RS-RFQ-005-2025 Request for Quotation NL Fire Station Showers

Addendum No. 2 (to the Request for Quotation Document)

New Liskeard Fire Hall Washroom Renovation

Drawing Title
FIRE SEPARATION
/ ASBESTOS REMOVAL
Project Title
N.L. Fire Hall
Washroom Renovation

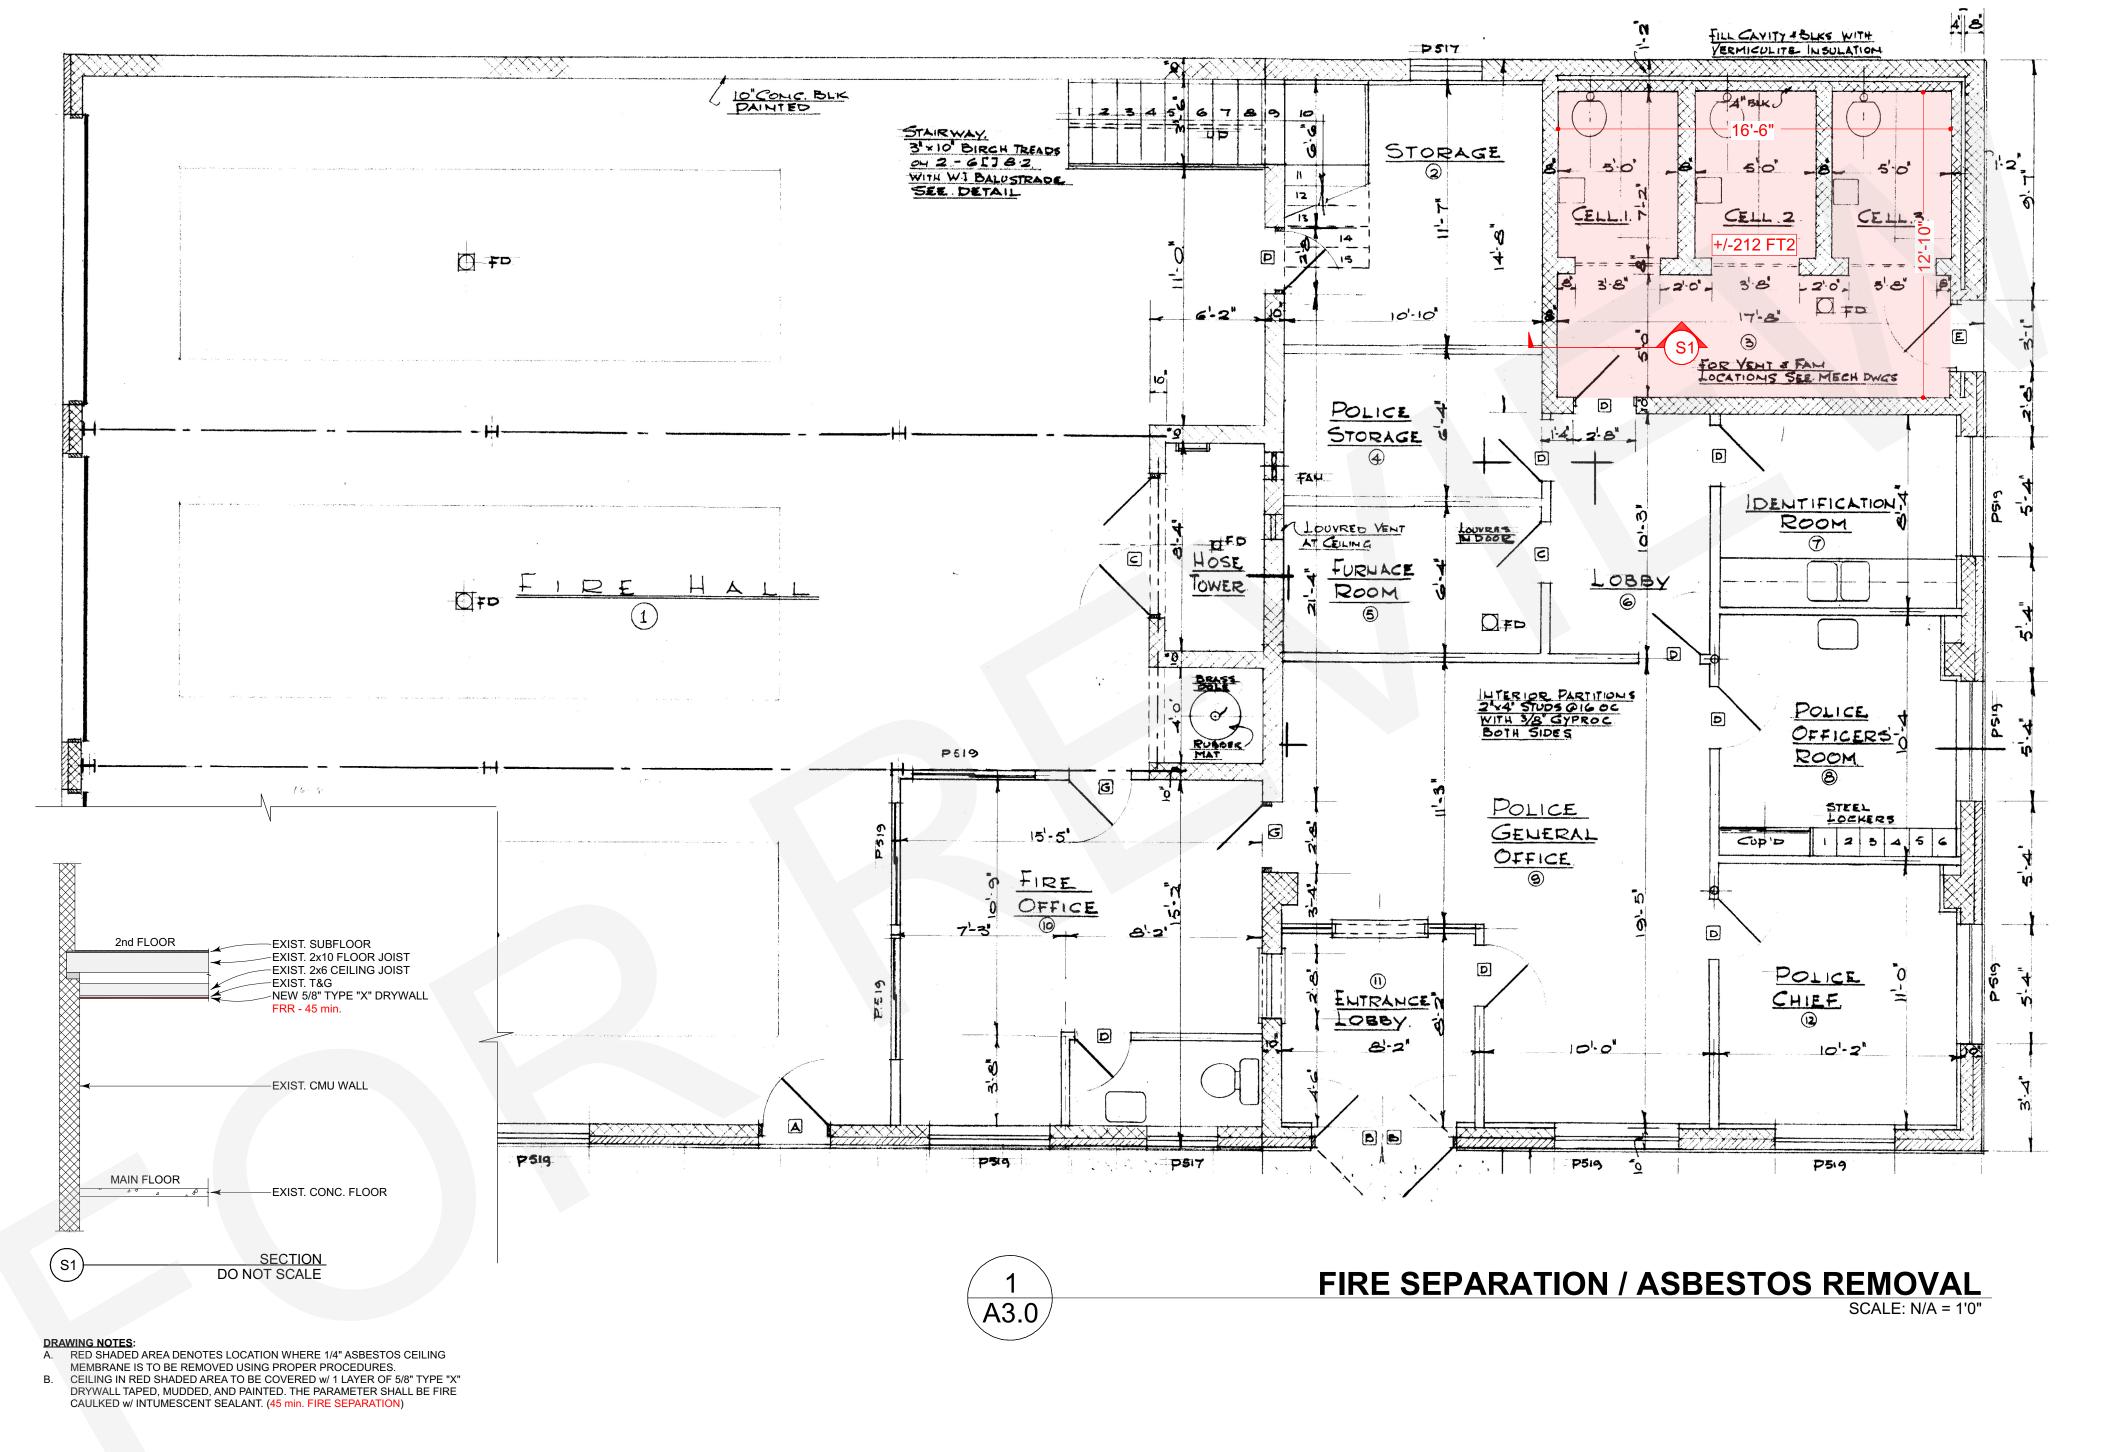
As part of the scope of work, the successful bidder shall be required to safely remove and dispose the 1/4" asbestos ceiling membrane in accordance with O.Reg. 347/90 and Occupational Health and Safety guidelines.

An updated IFC drawing (Appendix 02) has been included within this addendum which outlines this addition to the scope of work. It includes information on removing and replacing the existing asbestos ceiling membrane with a new fire rated material.
